MEMO

DATE: February 4, 2022
TO: Portland Historic Landmarks Commission
FROM: Brandon Spencer-Hartle, Lora Lillard, and Cassie Ballew, BPS
CC: Hillary Adam, BDS and Dan Layden, PBOT
SUBJECT: Earl Blumenauer Bridge Belgian Block Deployment Request

1/4 SECTION
1n1e35
PROJECT NO.
T00638
SHEET NO.
L-2

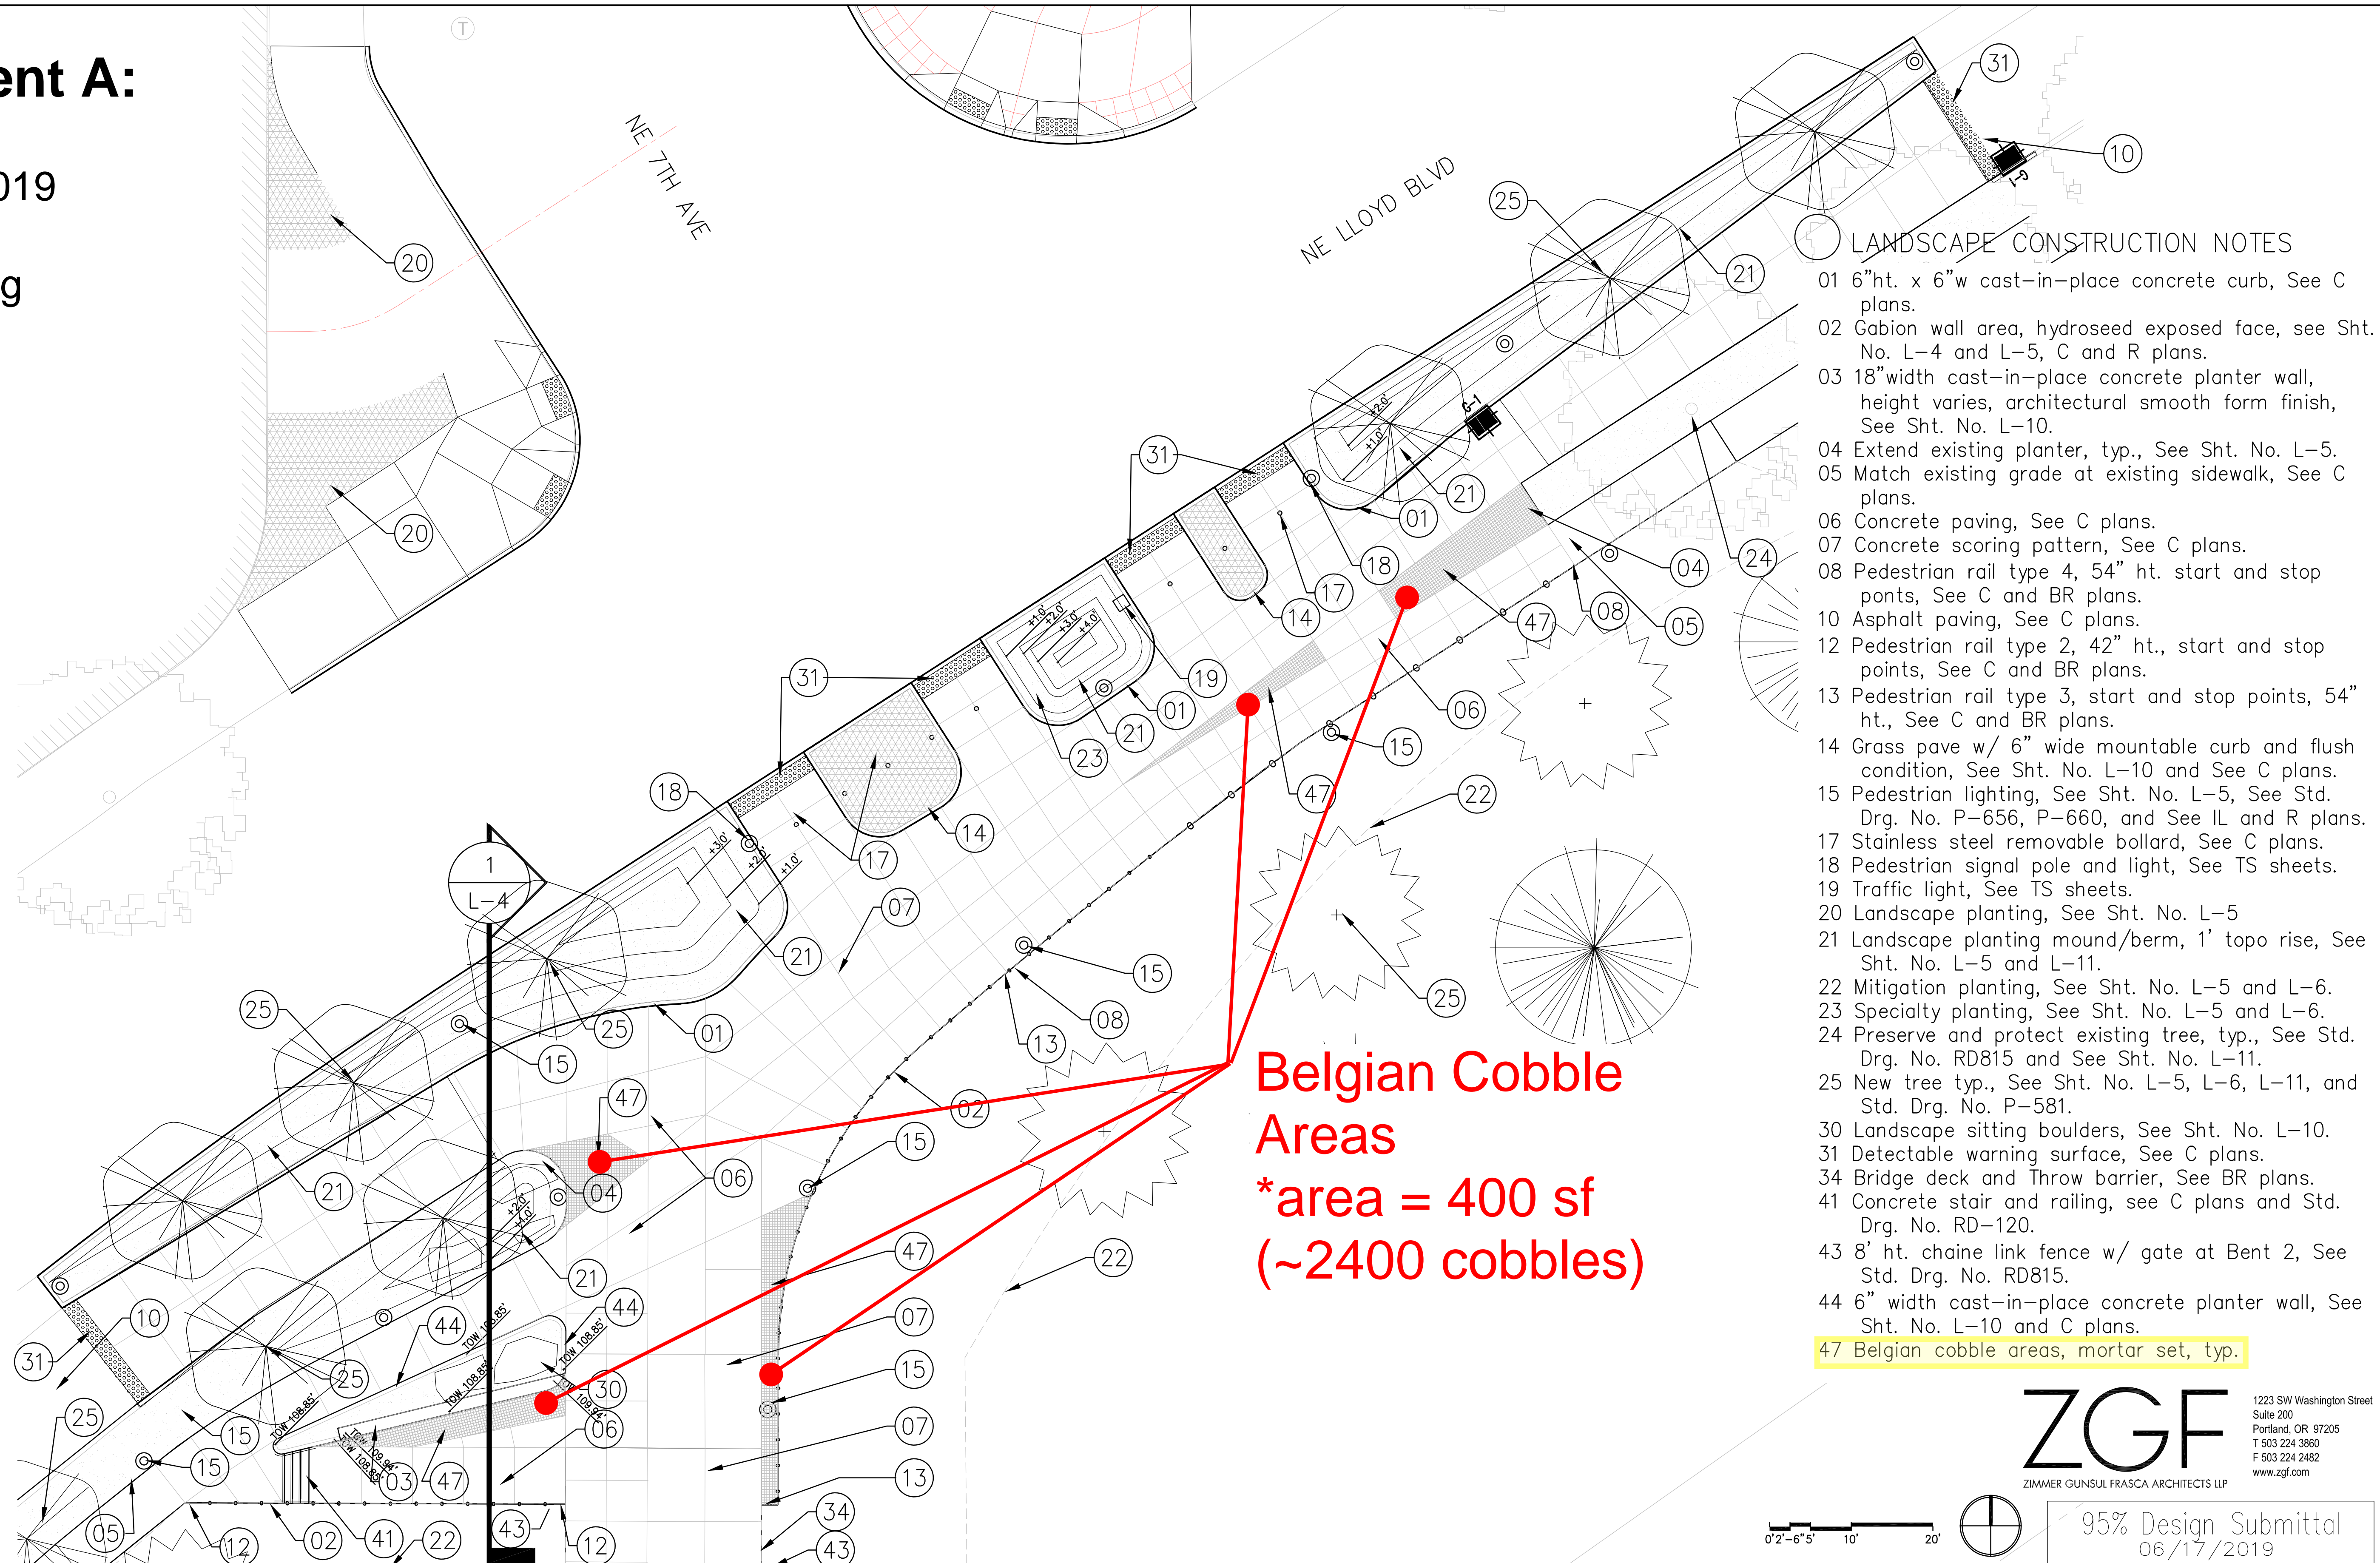
- Appreciate the use of the Belgian Blocks where it is serving to separate the bikes and pedestrians, like the triangular piece on L-2 (north landing), but not the curved area leading to the bridge where it feels like leftover space.
- Recognize that Belgian Blocks cannot be used in major areas for walking or on biking paths, per ADA, but they can mark the use of a larger change in grade or the use of the location of something like a boulder (e.g. north of the bridge where it’s an oval separation in the path). Cobbles could be used to build up toward the boulders.
- Location of blocks should be meaningful, such as marking the separation of grade or bikes and pedestrians. Not as a “decorative touch” sprinkled throughout.

At the conclusion of the November 2019 meeting, BPS and PBOT agreed to return with a refined design approach to the Belgian Blocks that would respond to the Commission’s concerns, specifically regarding Criterion 2.

1/4 SECTION
1n1e35
PROJECT NO.
T00638
SHEET NO.
L-2

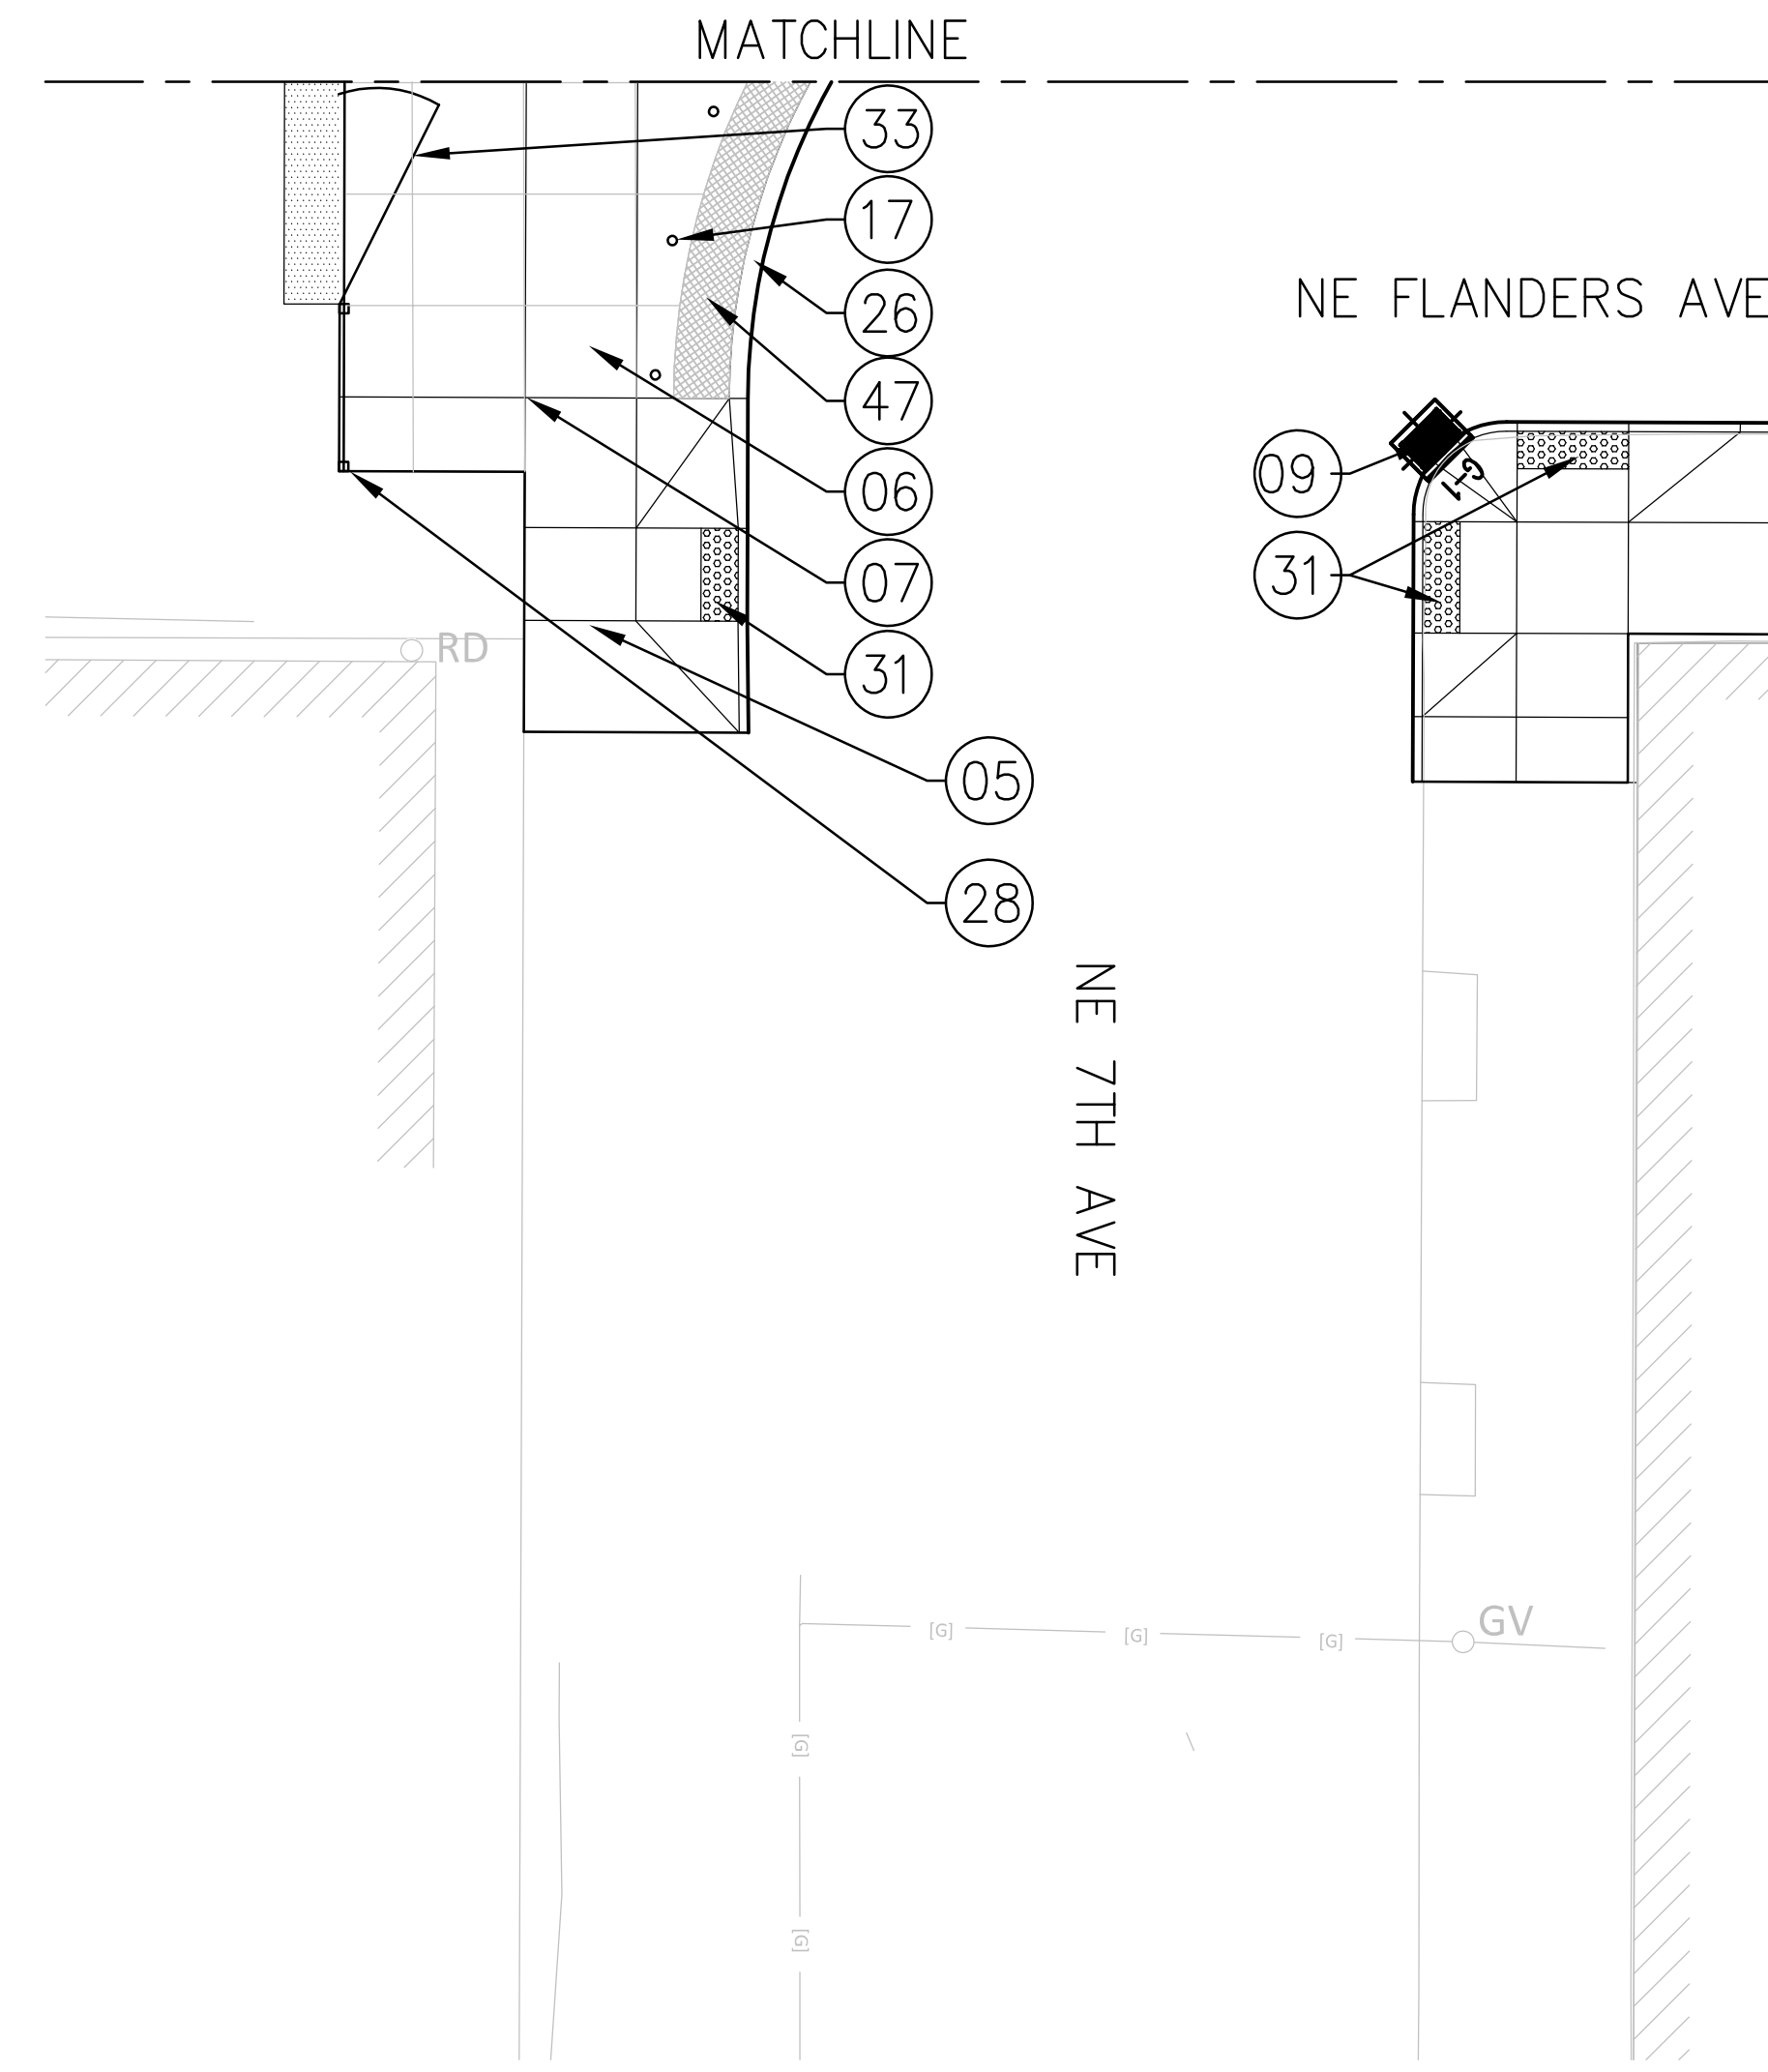
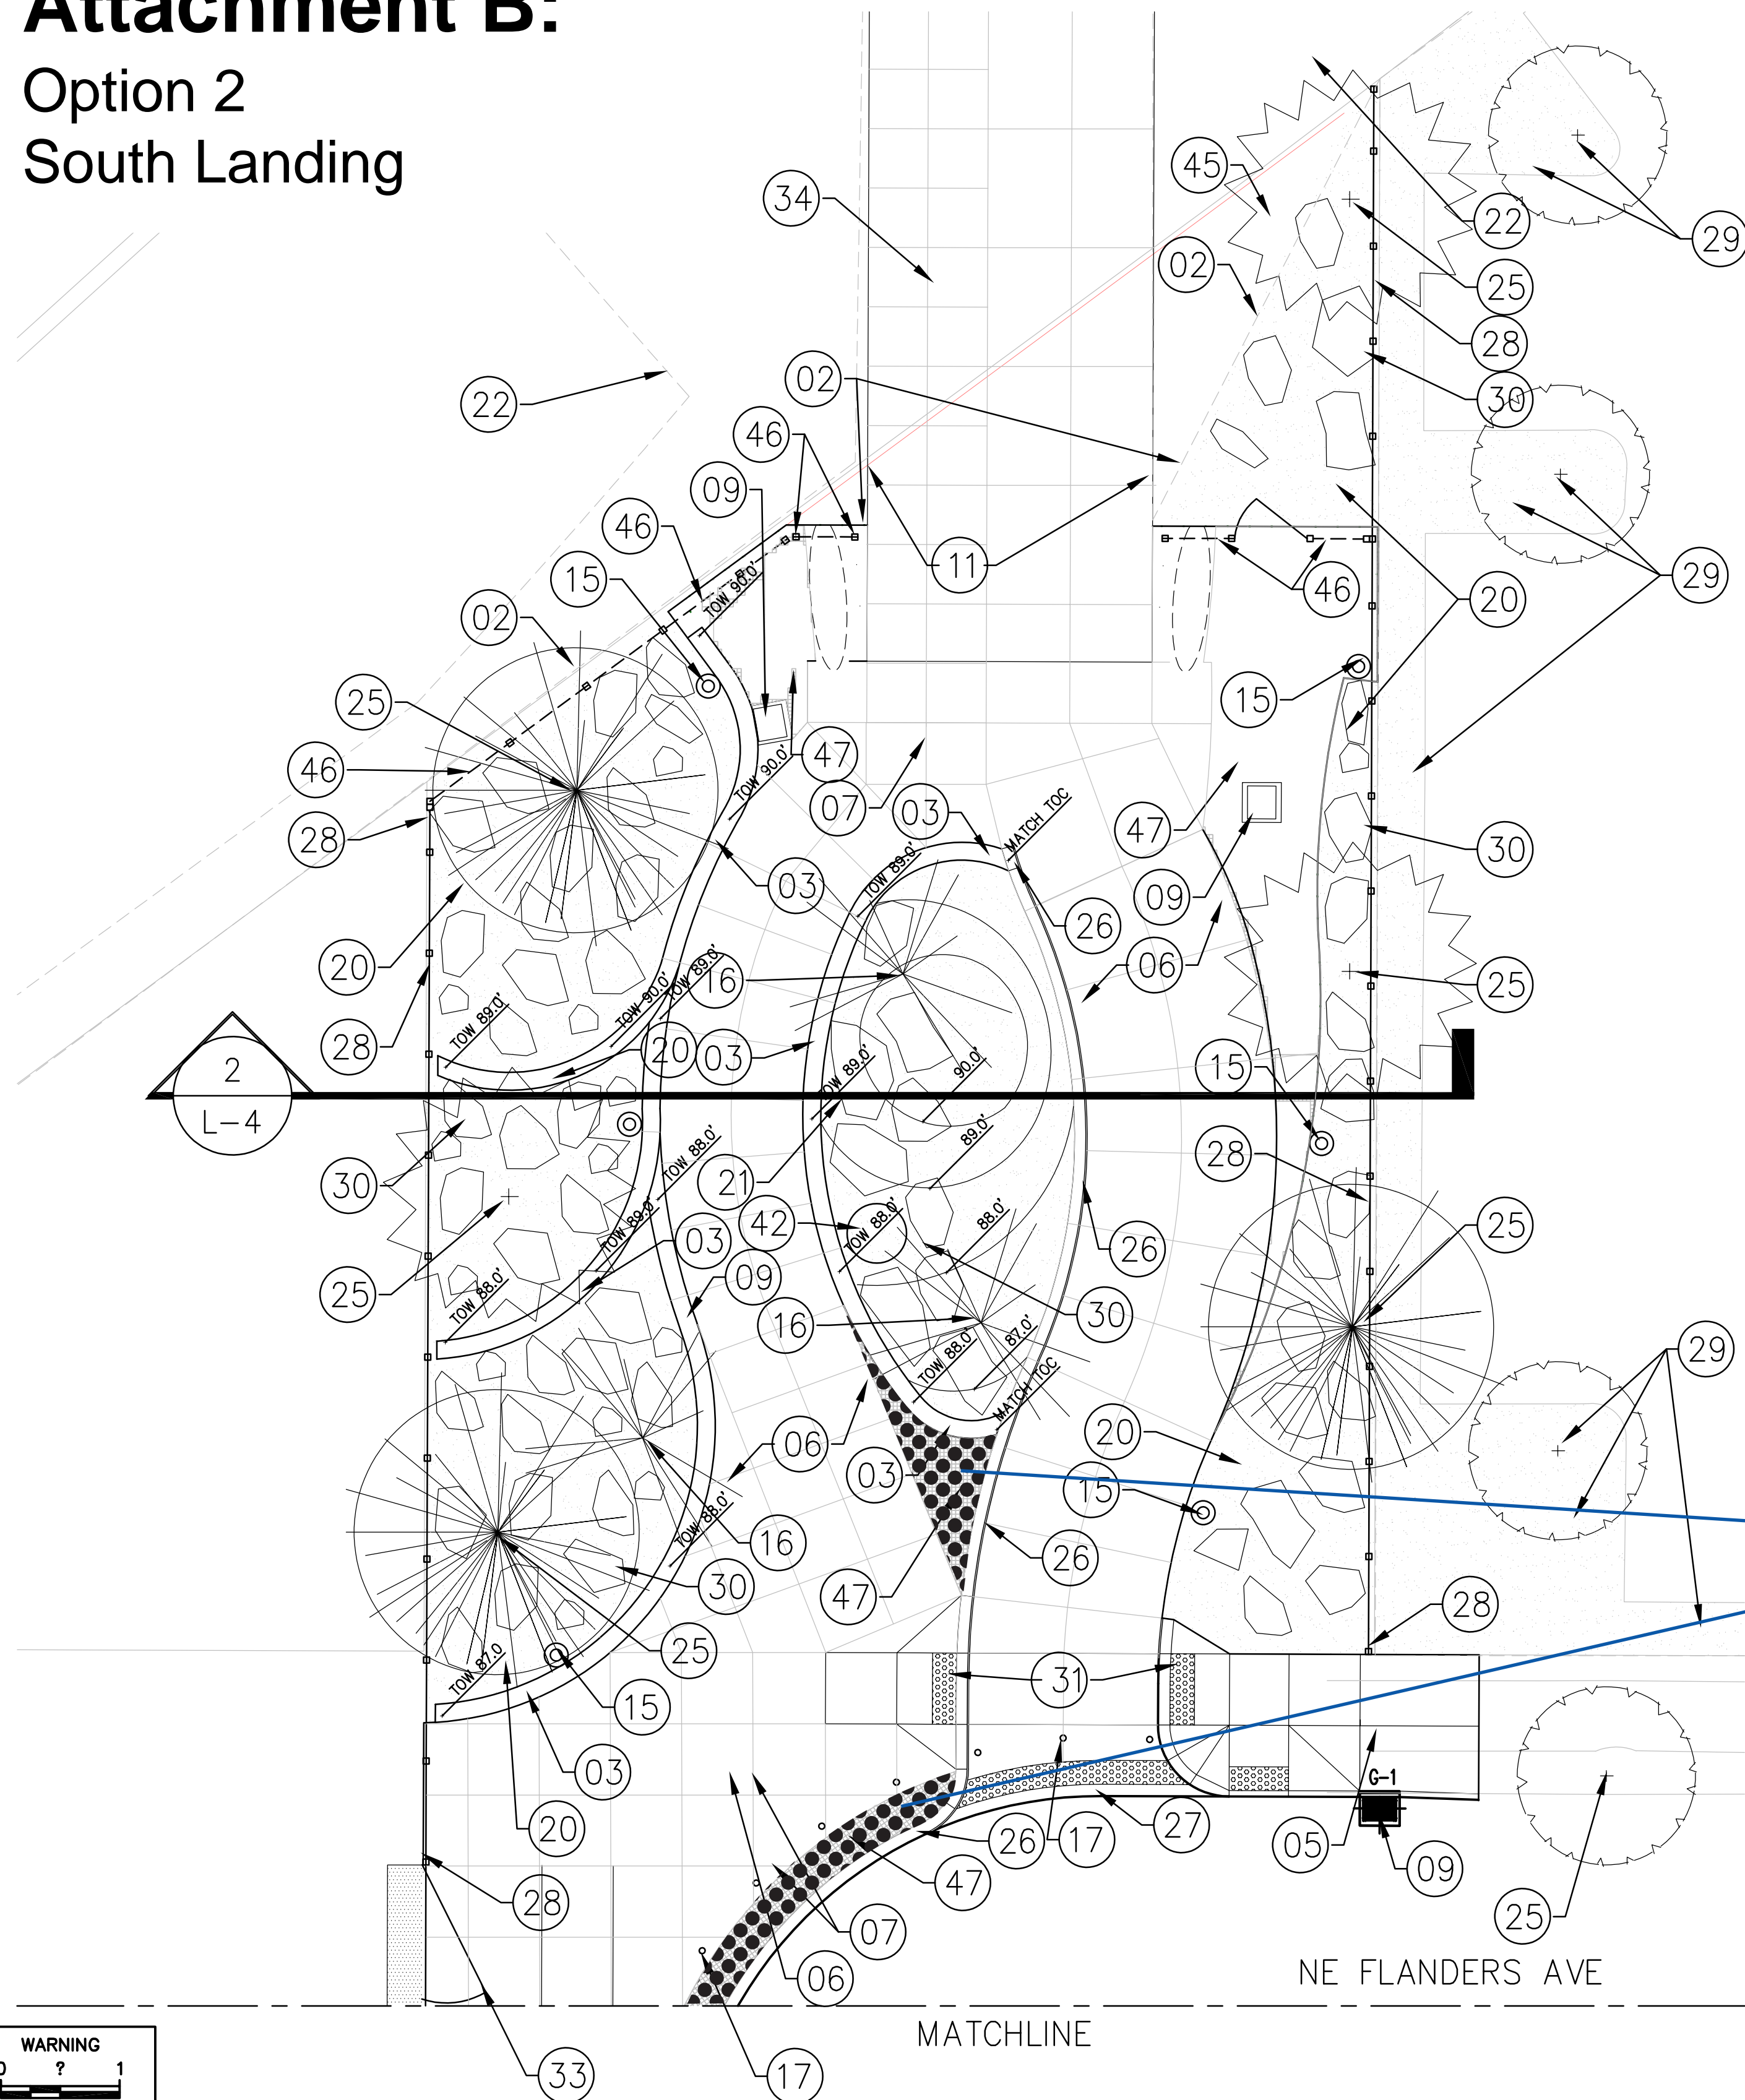
- **NORTH:** Belgian Blocks separate pedestrians and cyclists along Sullivan’s Gulch trail while also physically illustrating northeast-southwest flow.
- **SOUTH:** Belgian Blocks separate pedestrians and cyclists, as well as pedestrians and cars, moving in the direction of north-south flow and the curvature of NE Flanders.
